To: Area Managers
From: Don Fordiani - National Field and Dealer Operations Manager
Subject: Update - Owner Notification Phase - Customer Satisfaction Campaign (CSC) - CLA
 Certain 2013 Model Year GS 350 Vehicles
 Engine Control Module (ECM) Reflash

TECHNICAL INSTRUCTIONS
FOR
CUSTOMER SATISFACTION CAMPAIGN CLA
ENGINE CONTROL MODULE (ECM) REFLASH
CERTAIN 2013 MODEL YEAR GS350

UPDATED MAY 24, 2012

Updated 5/24/12

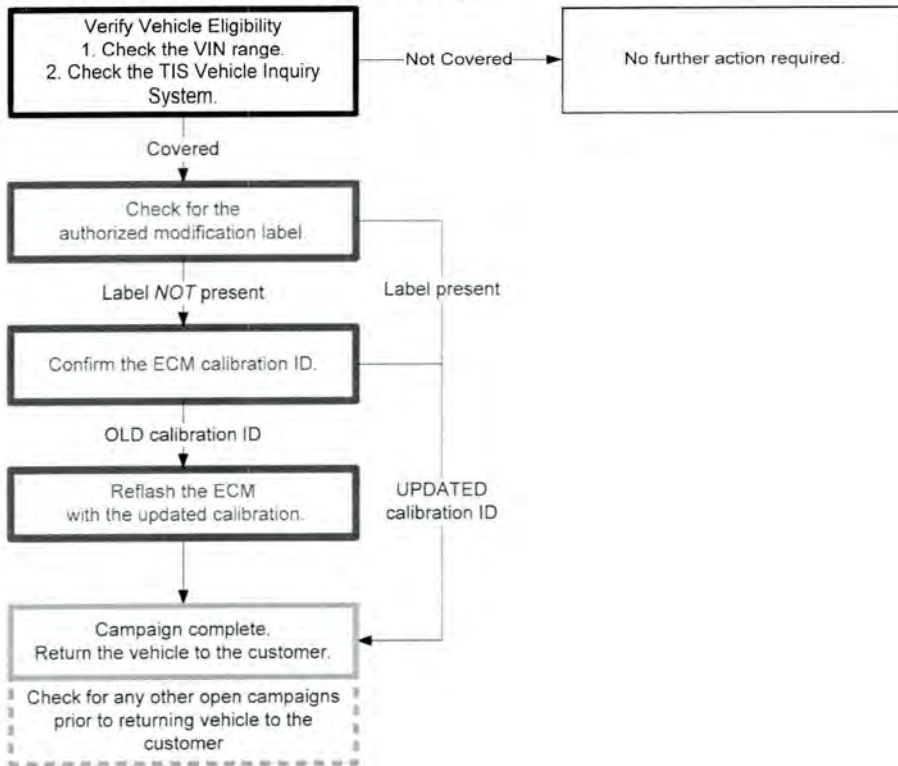
- Operation flowchart has been updated (SECTION I)
- Warranty Claim Submission Guidelines have been added (SECTION VII)

- VIN information has been added
- Reflash procedure has been updated (SECTION VI)
